Voxx Accessories Corp.

FCC Class II Permissive Change Request Letter

RE: FCC Permissive II Change Request for Company: Voxx Accessories Corp.
FCC ID: VIXPNP100

PCB layout
Original:

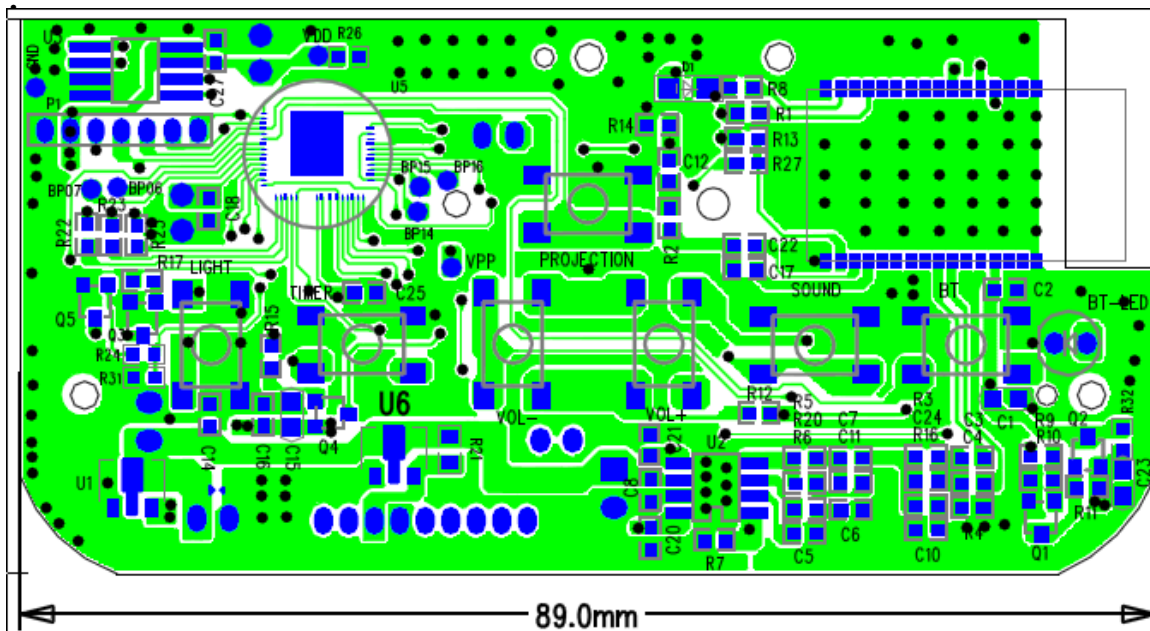
- The BT Module remains the same, the circuit diagram remains the same.
- Only the size of the MCU chip and PCB layout around the MCU chip are changed(see below page)

The size of
the chip and
PCB layout
changed
